Re: Russell #95 Marron (NM-03605) ^{Largo-} Chacra Pool
1980 FSL - 1960 FWL, Section 23, T 27 N - R 8 W
San Juan County, New Mexico

Re: Application for Non-Standard
Location: Marron Well No. 95,
1980 FSL & 1960 FWL of Sec. 23,
T-27-N, R-8-W, San Juan County,
New Mexico

We may not process the subject application for non-standard location until the required information or plats checked below (is)(are) submitted.

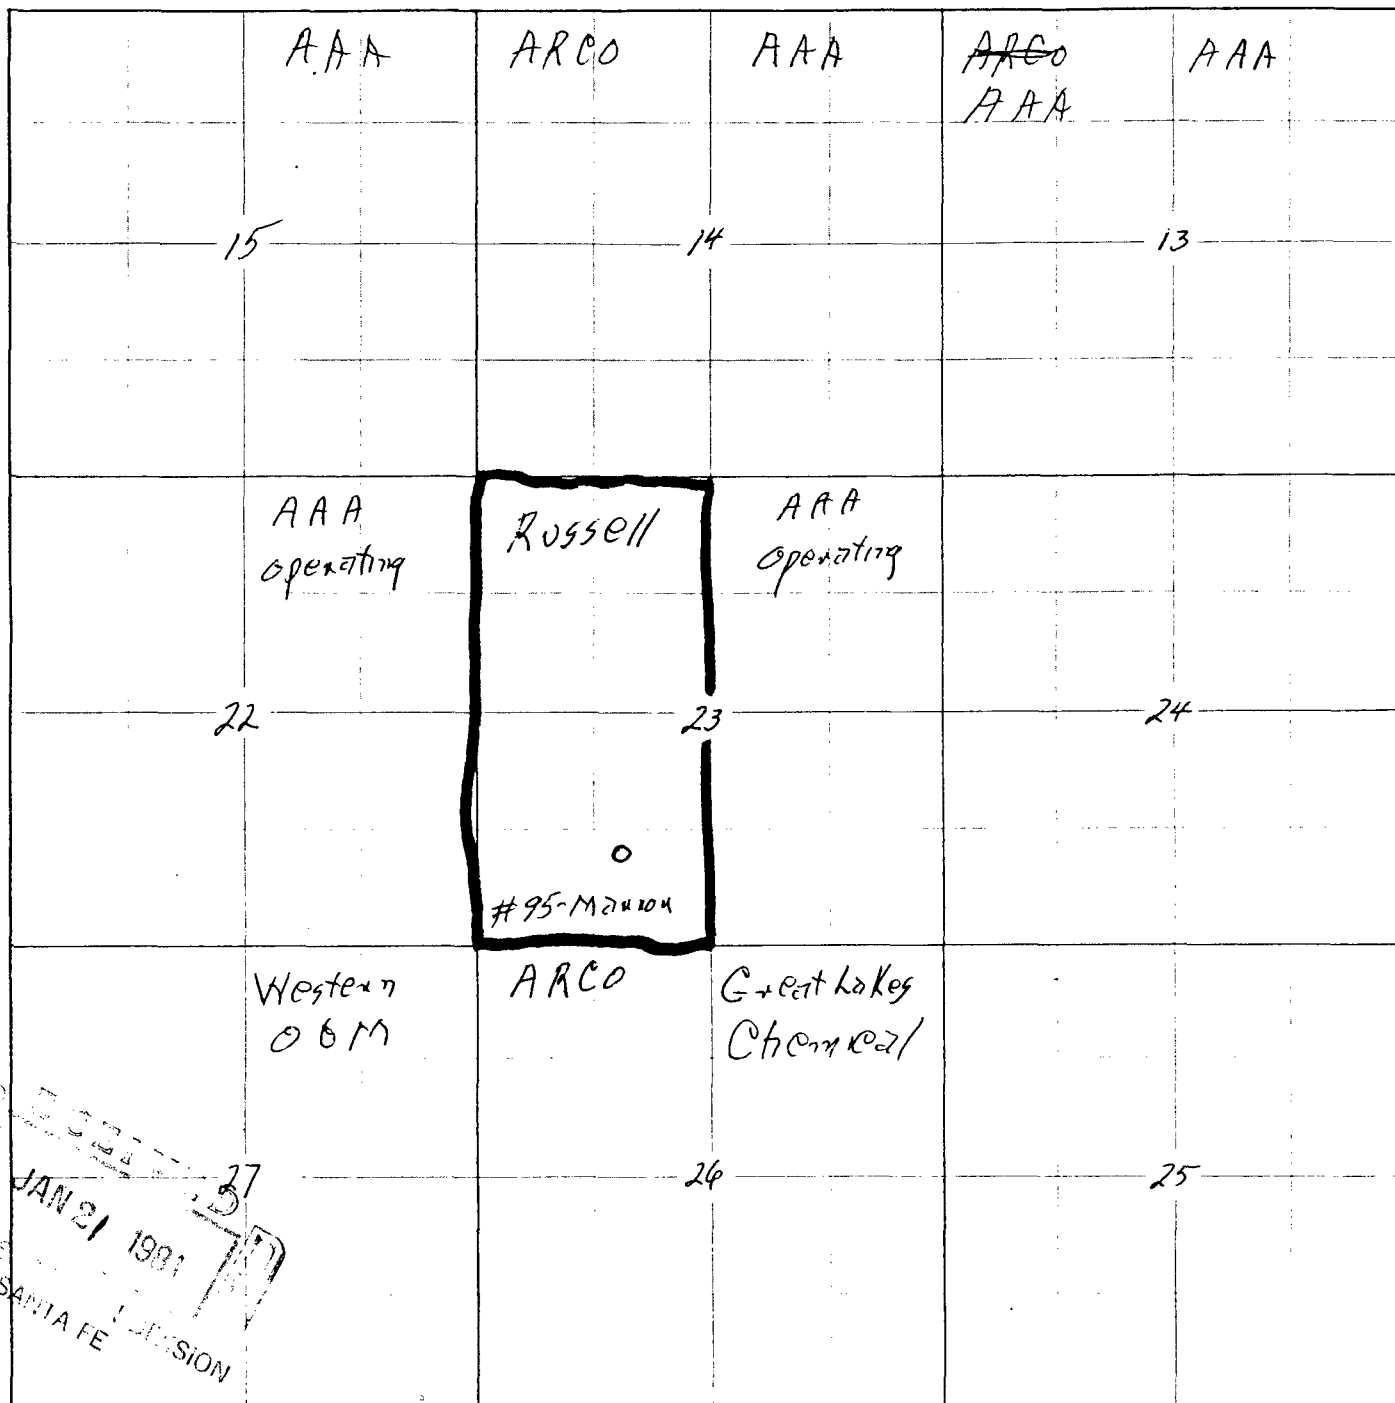
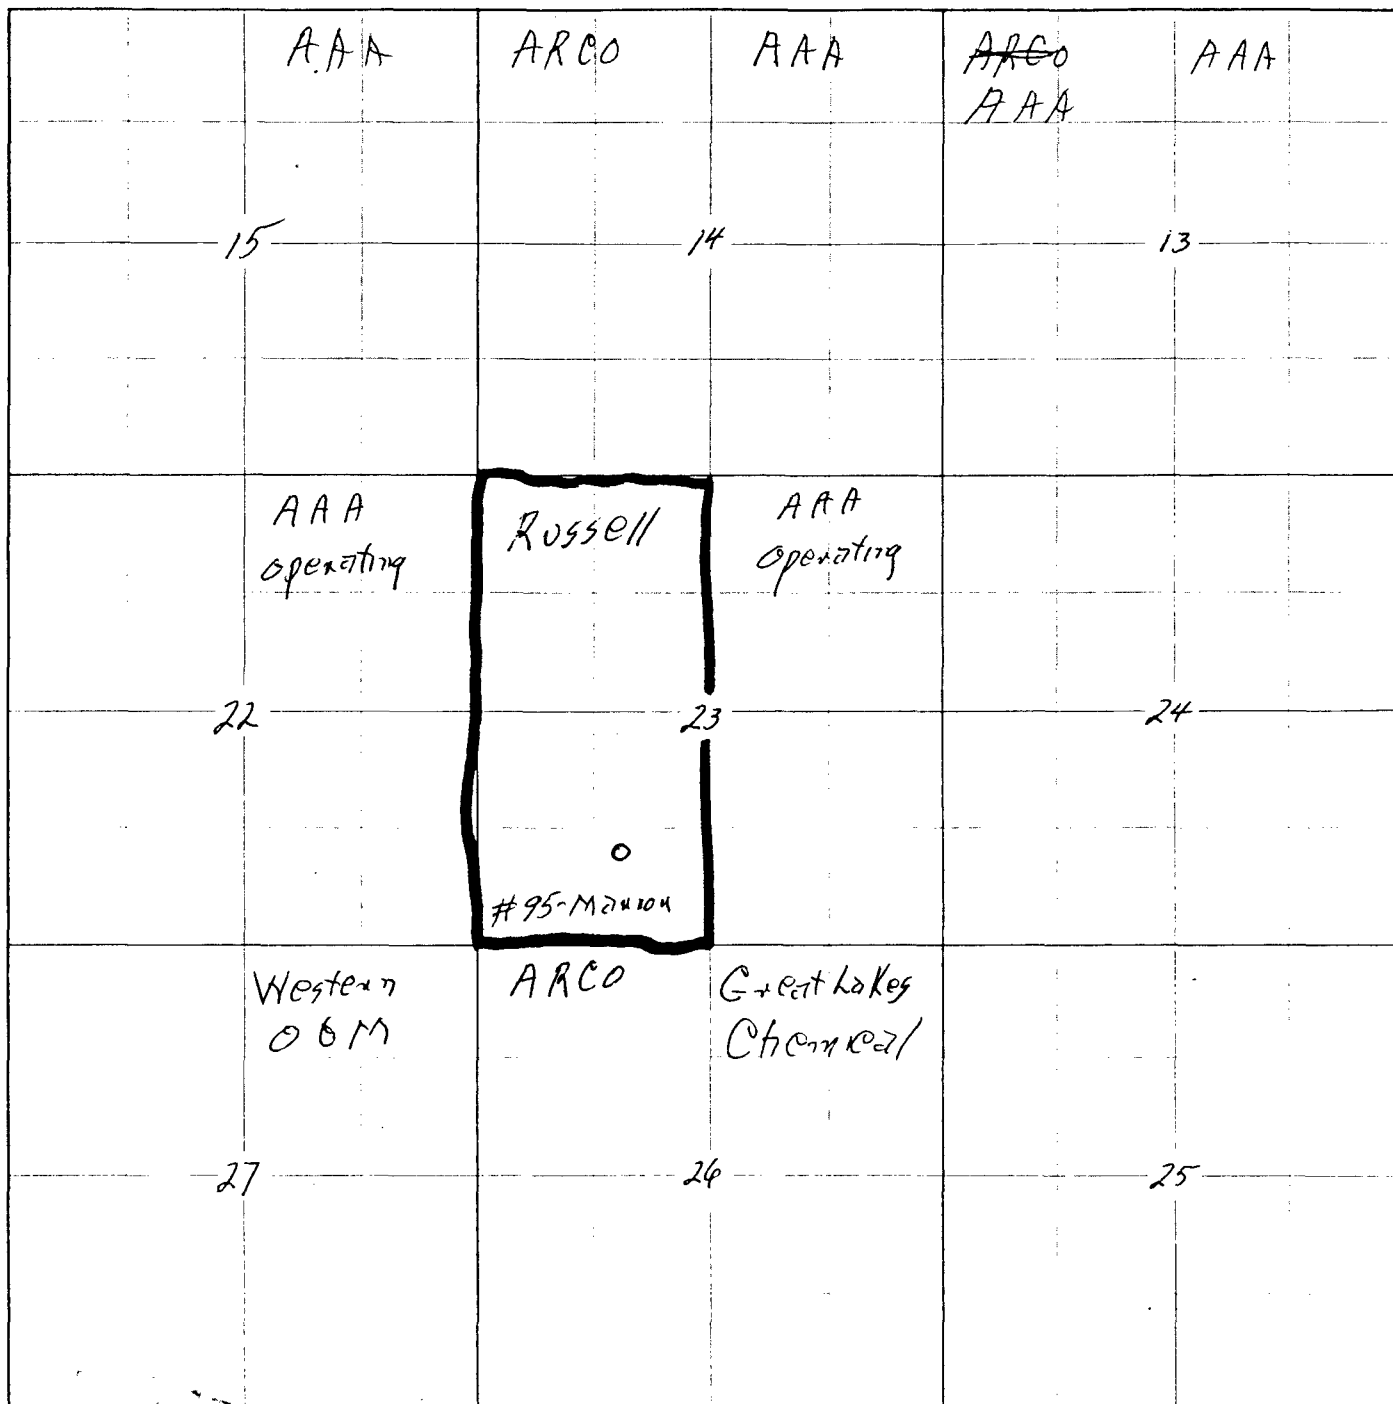
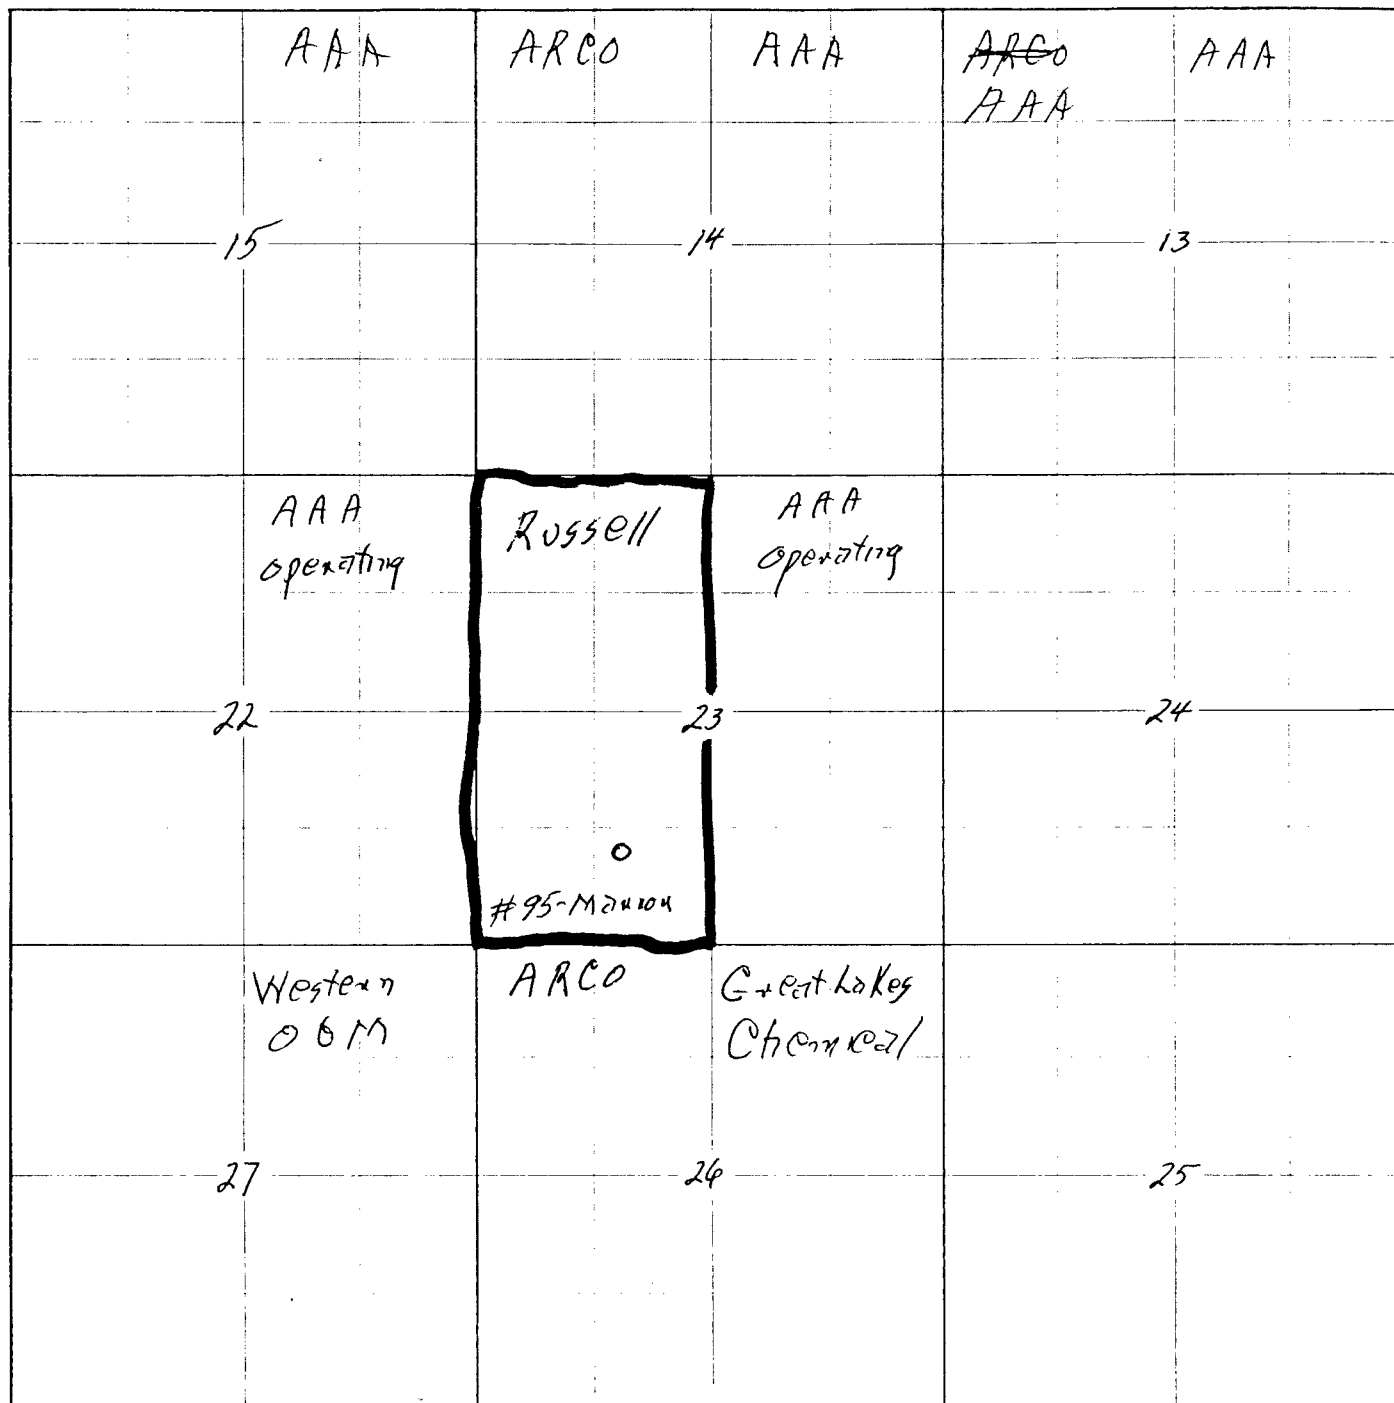
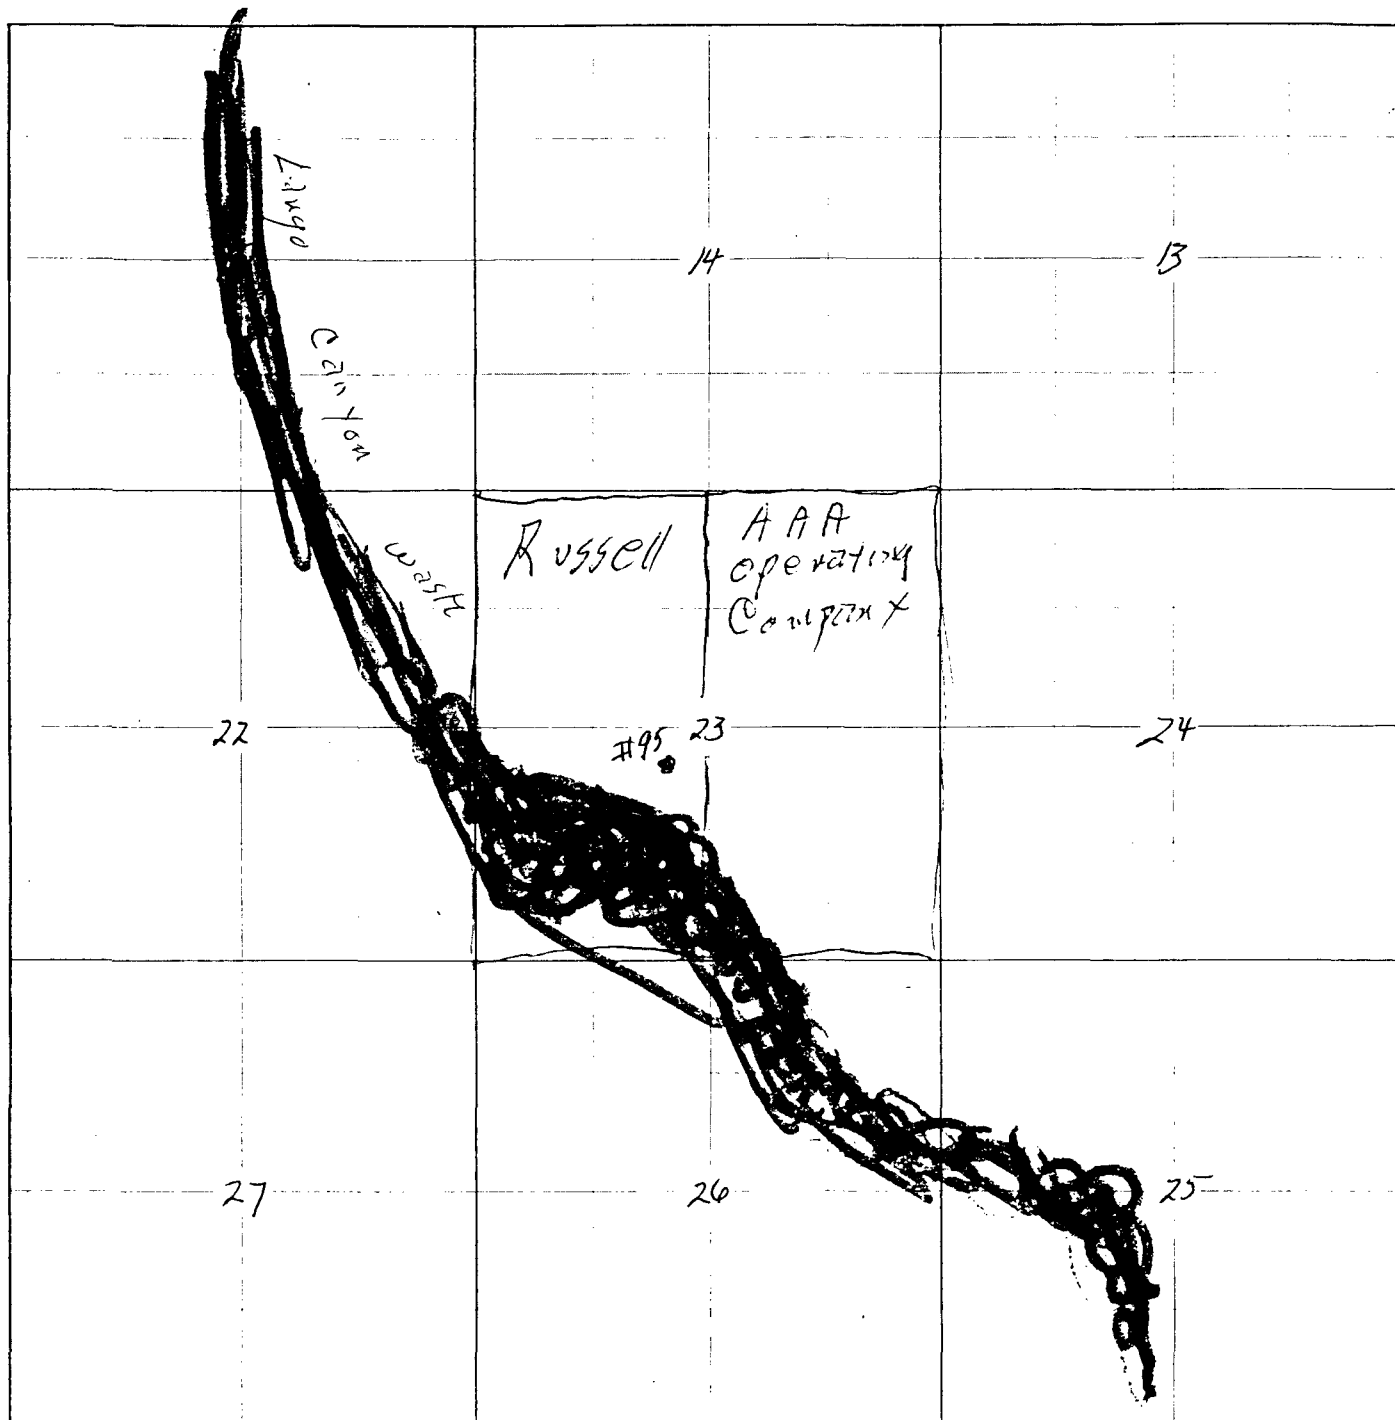
- ☒ A plat must be submitted clearly showing the ownership of the offsetting leases, including those in Section 22, 26 & 27
- ☒ A statement must be submitted that offset owners have been notified of the application by certified mail, including those in Section 22, 26 and 27.
- ☐ A plat must be submitted fully identifying the topography necessitating the non-standard location.
- ☐ Other:
